No. 2242, Rev. 1
ATA Code 27-30
Recurring Inspection

SUBJECT: FLIGHT CONTROLS - INSPECTION AND/OR REPLACEMENT OF MAGNESIUM ELEVATOR CONTROL FITTINGS

SYNOPSIS OF CHANGE: Corrected location of P/N 35-660031-2 in MATERIAL. Clarified Composition Test and deleted Step 3 in ACCOMPLISHMENT INSTRUCTIONS.

Figure 1

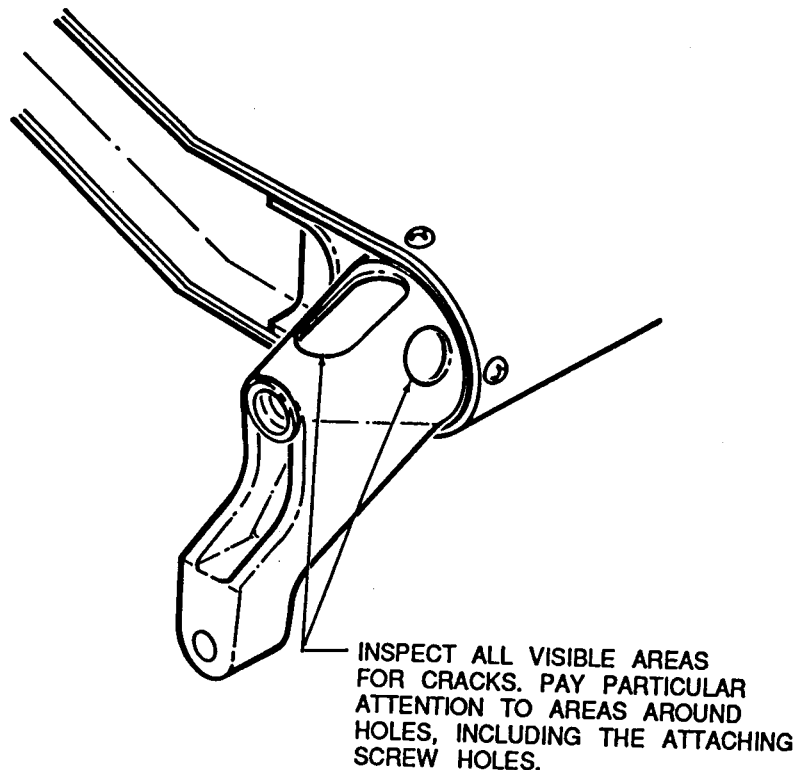
1. Refer to Figure 1 and inspect both elevator control fittings as shown.

2. Ensure correct freedom of movement of both elevator control fittings.

Figure 2

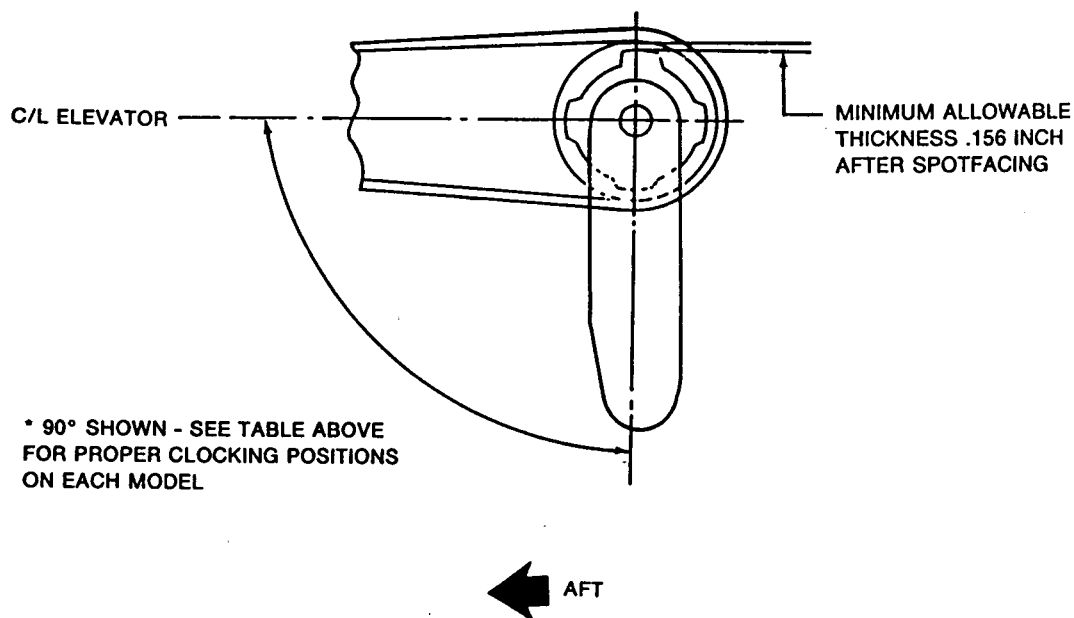
- a. Remove the elevator from the airplane and remove the existing fitting from the elevator.
- b. Install a new elevator control fitting on the elevator in the correct position. Refer to Figure 2 for correct position.
- c. Mark one hole on the new fitting, using an existing hole in the elevator as a template.

g. Back spot face the four holes (on the inside of the fitting) until a flat surface is obtained. The minimum allowable thickness of the spotfaced area is .156 inch. Refer to Figure 2.

i. Use new hardware for the new fitting installation. See Figure 2.

MODEL	CLOCKING POSITION, WITHIN
33 Series Airplanes	90°
Model 45 Series - T34A & T34B	67° 20 minutes
35 through J35	67° 20 minutes
K35 through V35B	71° 20 minutes (LH) 67° 20 minutes (RH)
36 through A36	88°
A36TC (EA-1 through EA-272)	88°
B36TC (EA-273 through EA-328)	83°
B36TC (EA-329 and after)	81°
55 Series Airplanes 56TC, 58	90°
58P, 58TC, T42A, 95 Series Airplanes	90°

DRILL 4 .190/.194 INCH DIAMETER HOLES

**BACK SPOTFACE 9/16 WITH .06 INCH CORNER RADIUS (EXCEPT
V-TAIL BONANZAS AND T34A & T34B AIRPLANES)
MINIMUM ALLOWABLE THICKNESS, .156 INCH AFTER SPOTFACING
AN23-9A /M/ BOLT (4 PLACES) (ALL AIRPLANES EXCEPT
V-TAIL BONANZAS AND T34A & T34B AIRPLANES)**

**AN23-10A /M/ BOLT (4 PLACES) (V-TAIL BONANZA AND T34A
& T34B AIRPLANES ONLY)**

**AN960-10 WASHER (4 PLACES)
130909N29 NUTS (4 PLACES)**

USE NEW HARDWARE FOR REINSTALLATION OF FITTING

Fuel Strainer Components
Figure 1

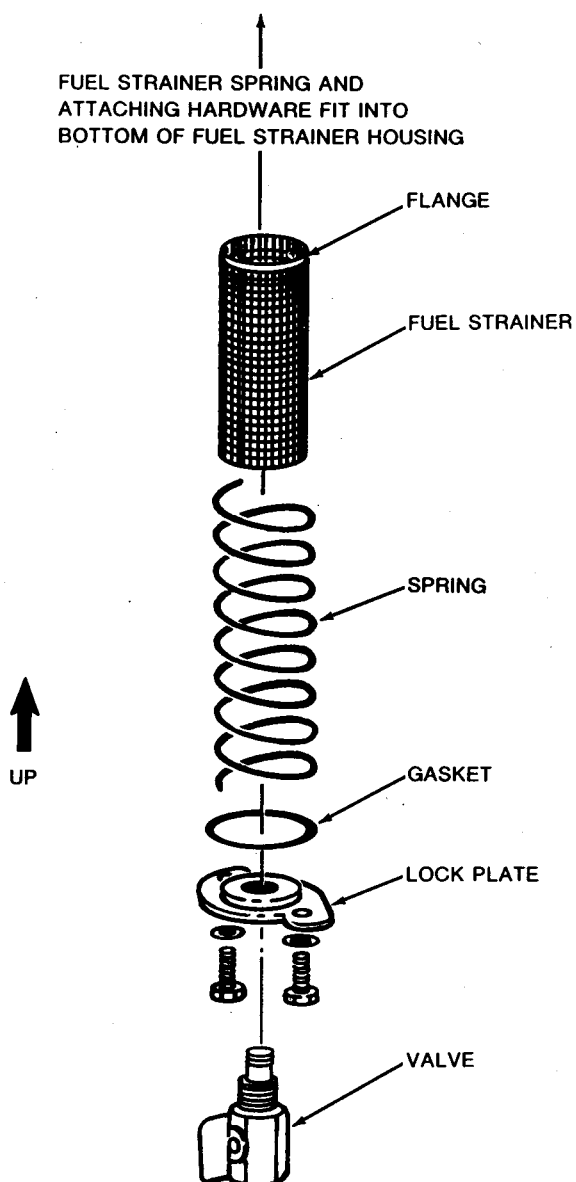
1. Turn the fuel selector to the OFF position.
2. Gain access to the fuel strainer housing by opening the fuel drain access door under the fuel strainer housing.
3. Refer to Figure 1, remove the lock plate and check to ensure that the fuel strainer and spring are installed correctly.

5. If required, reposition the strainer and spring to ensure correct configuration.

IT IS POSSIBLE TO INSTALL THE FUEL STRAINER UPSIDE DOWN. The strainer must have been inserted into the fuel strainer housing prior to insertion of the spring. The strainer has a flange which

Figure 1

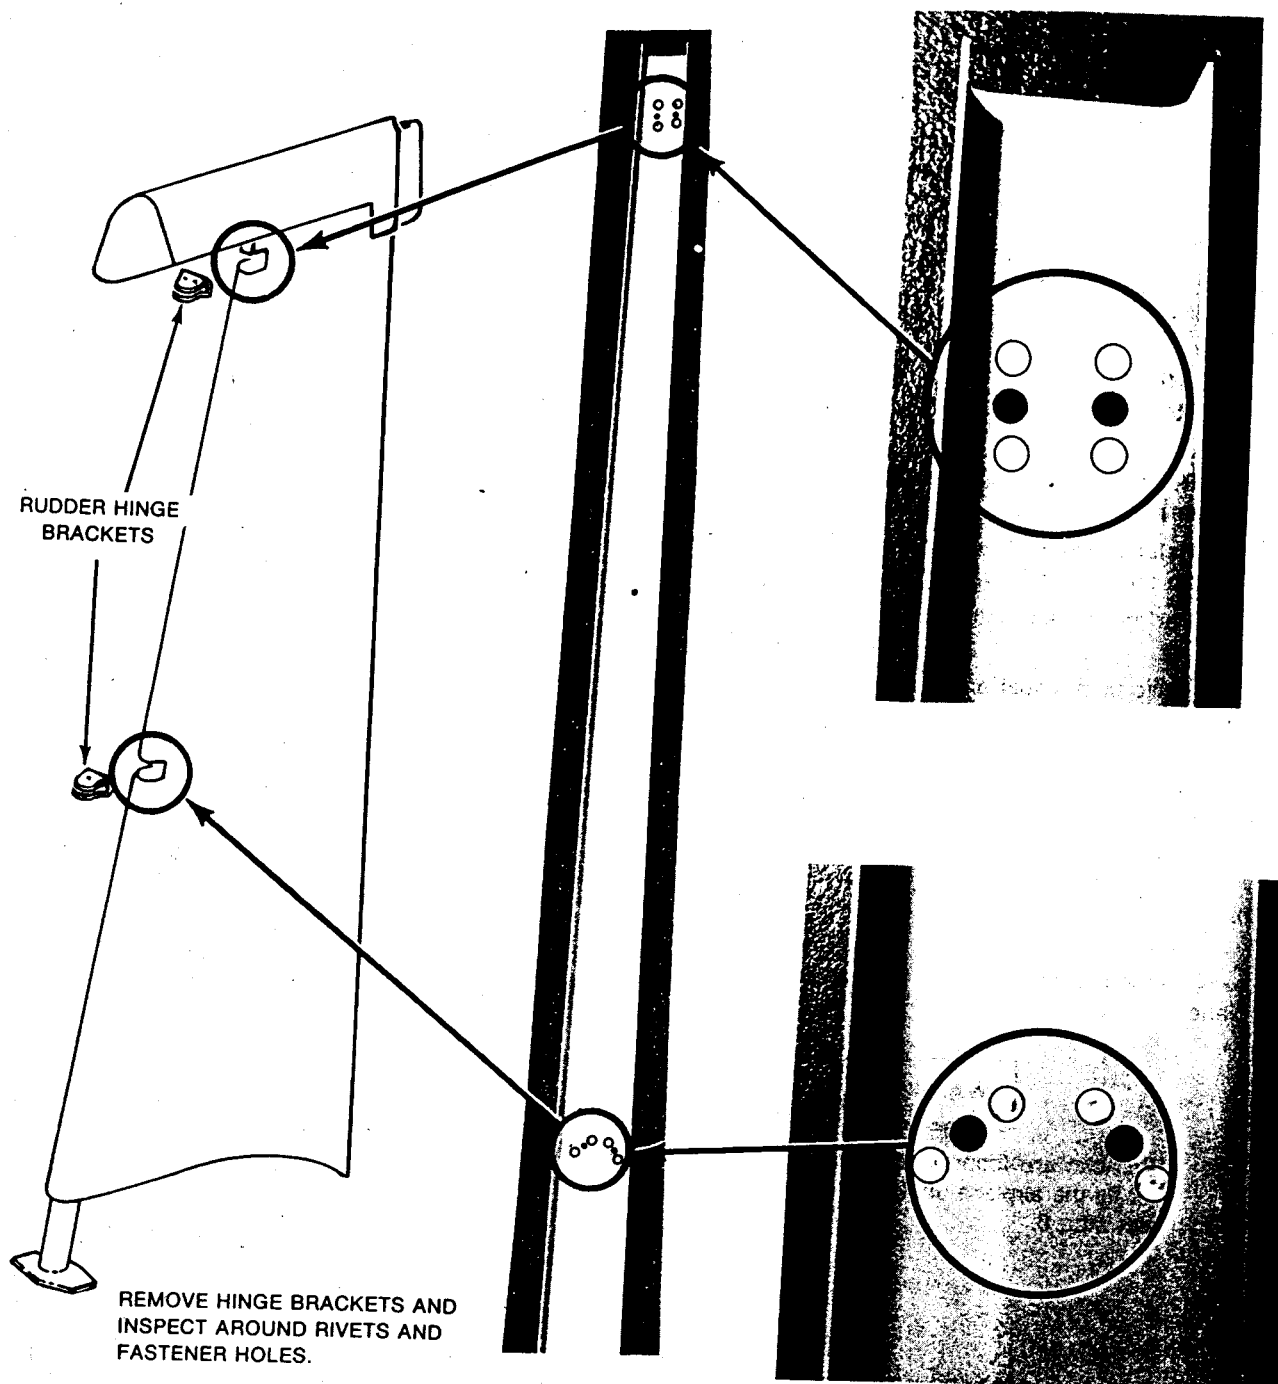
1. Refer to the appropriate shop/maintenance manual and remove the rudder from the airplane.
2. Refer to Figure 1 and remove the two hinge brackets from the rudder forward spar.
3. Perform a visual inspection of the entire rudder and spar.
4. Perform a visual and a dye penetrant inspection, using visible dyes, on the spar, in the areas around the hinge brackets. Pay particular attention to the following areas:
 - a. Areas around rivets which are used to attach the nutplates.
 - b. The holes for the screws which attach the hinge brackets to the spar.
5. If no cracks are found install the hinge brackets back on the rudder and install the rudder back on the airplane.

- b. When inspecting the rudder, open the inspection covers adjacent to the upper and center hinges. Inspect ribs, spar, hinges, and all rudder components in the areas of the hinges for attachment security, cracks, and general condition using a flashlight and mirror.

Inspection for Cracks in the Wing Forward Spar Carry-Thru
Figure 1

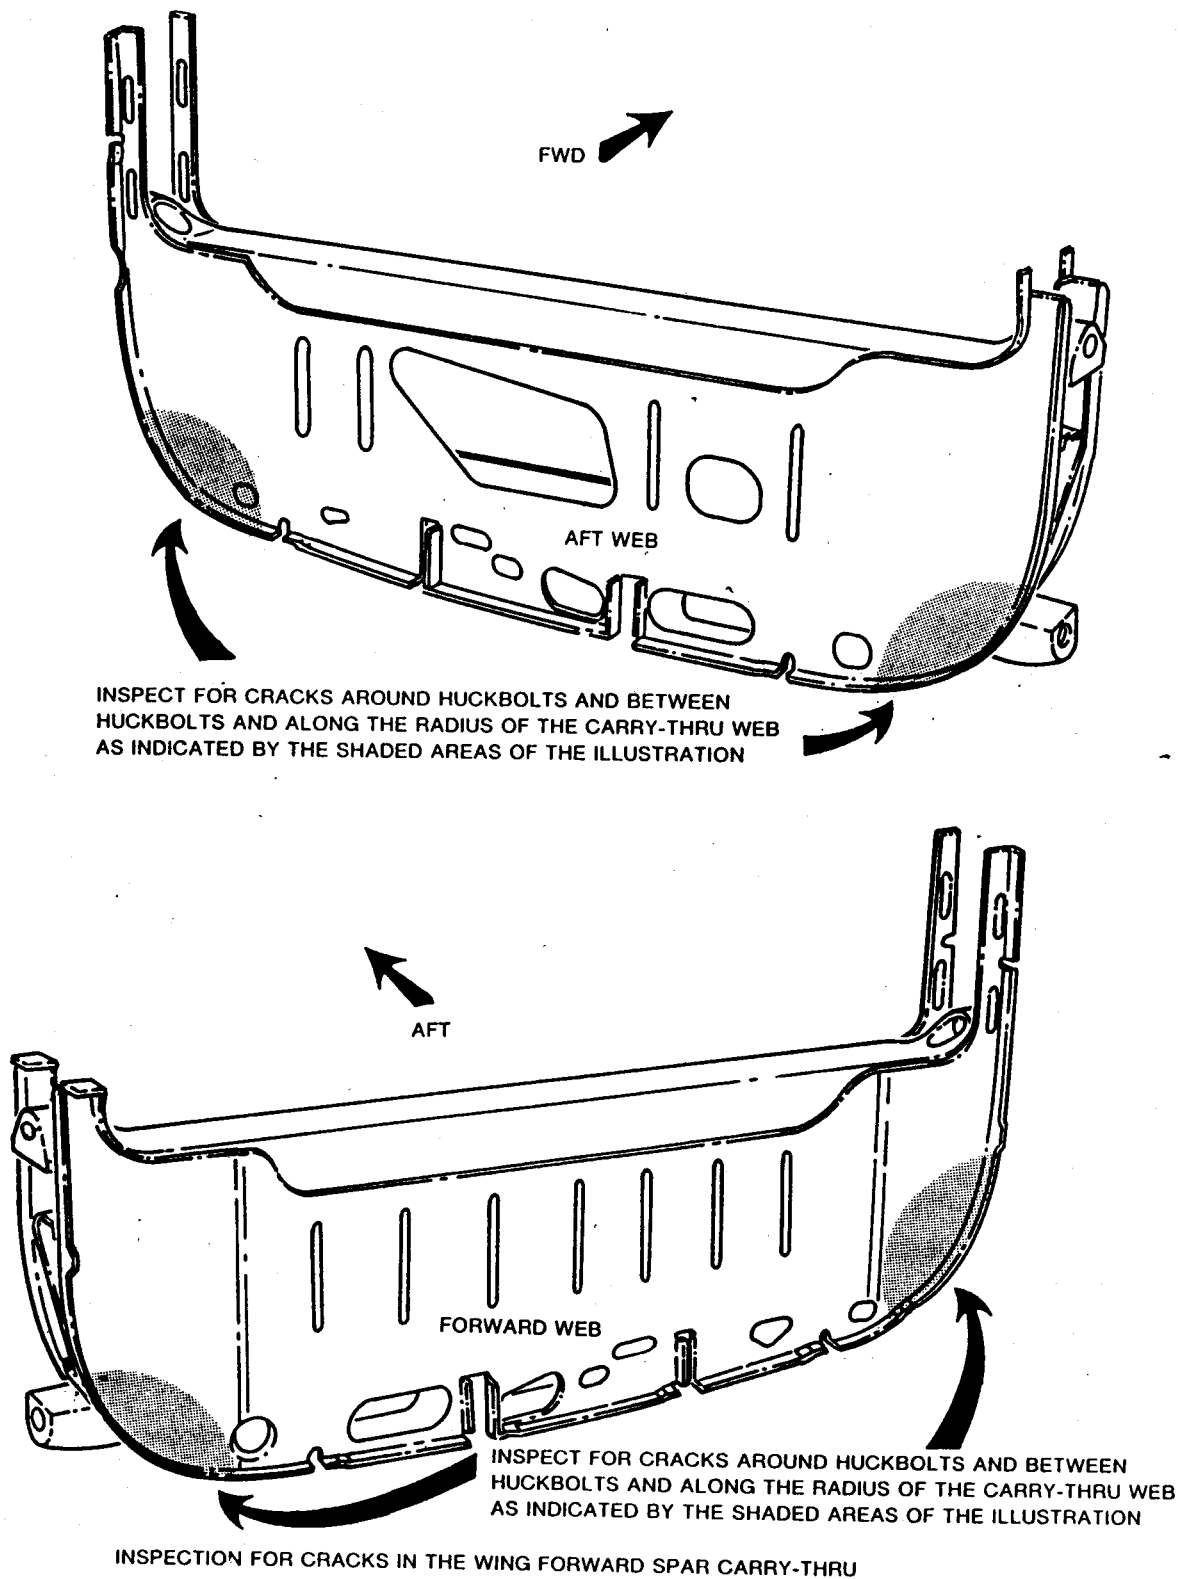
1. Remove the pilot's and copilot's seats and the carry-thru cover to obtain access to the front spar carry-thru structure.
2. Thoroughly clean the forward and aft frames (webs) of the front spar carry-thru structure in the areas shown in Figure 1.
3. Perform a visual inspection of the area cleaned in step 2 for evidence of cracks.
4. Perform a dye penetrant inspection, using visible dyes, of the area cleaned in step 2 for evidence of cracks.

Any of the areas shown in Figure 1 that are modified by the installation of a doubler need not be dye-penetrant inspected until 1500 flight hours after the installation of that particular doubler. If no cracks are found, repeat the inspection every 500 flight hours.

Areas shown in Figure 1 that have cracks that fall within allowable limits and that have not been modified by a doubler must be inspected or repaired as indicated in this Service Bulletin on an individual basis.

**Areas to be Color Coded
Figure 1**

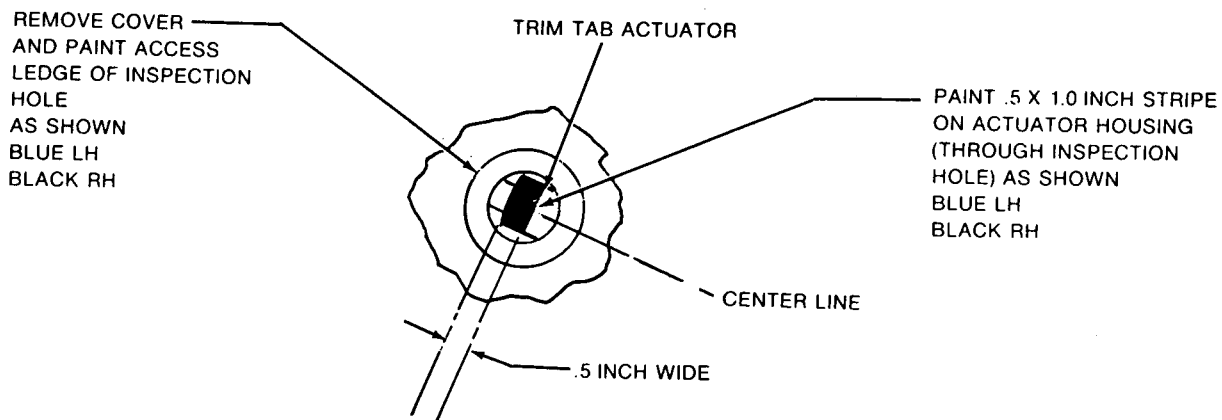
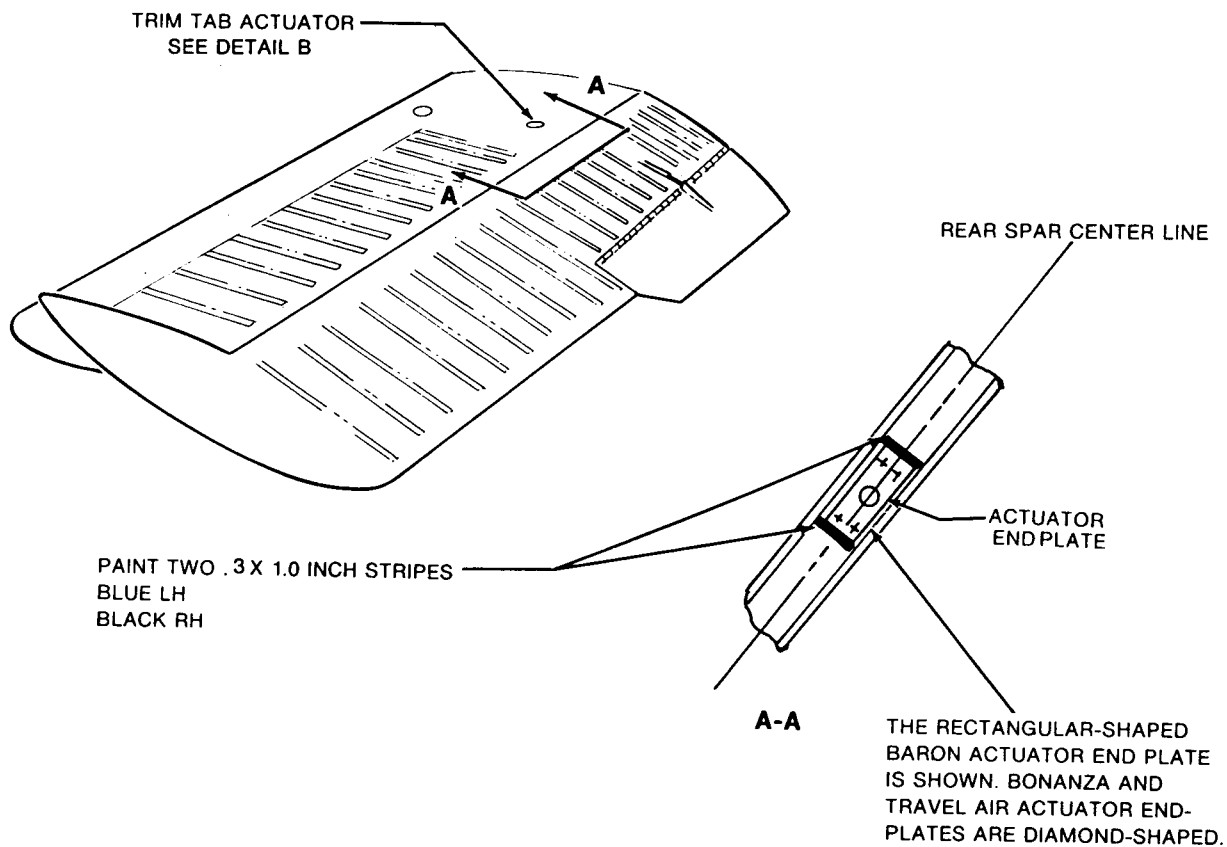
1. Paint two blue stripes approximately 0.3 inch wide by 1.0 inch long at right angles to the stabilizer spar cen-

terline next to each end of the LH elevator trim tab actuator endplate, as shown in Figure 1.

2. Remove the cover from the LH actuator inspection hole and paint the inspection hole ledge blue, as shown in Figure 1.

3. Paint a 0.5 inch wide by 1.0 inch long blue stripe around the LH actuator housing through the inspection hole, as shown in Figure 1.

5. Paint two black stripes approximately 0.3 inch wide by 1.0 inch long at right angles to the stabilizer spar centerline next to each end of the RH elevator trim tab actuator endplate, as shown in Figure 1.

6. Remove the cover from the RH actuator inspection hole and paint the inspection hole ledge black, as shown in Figure 1.
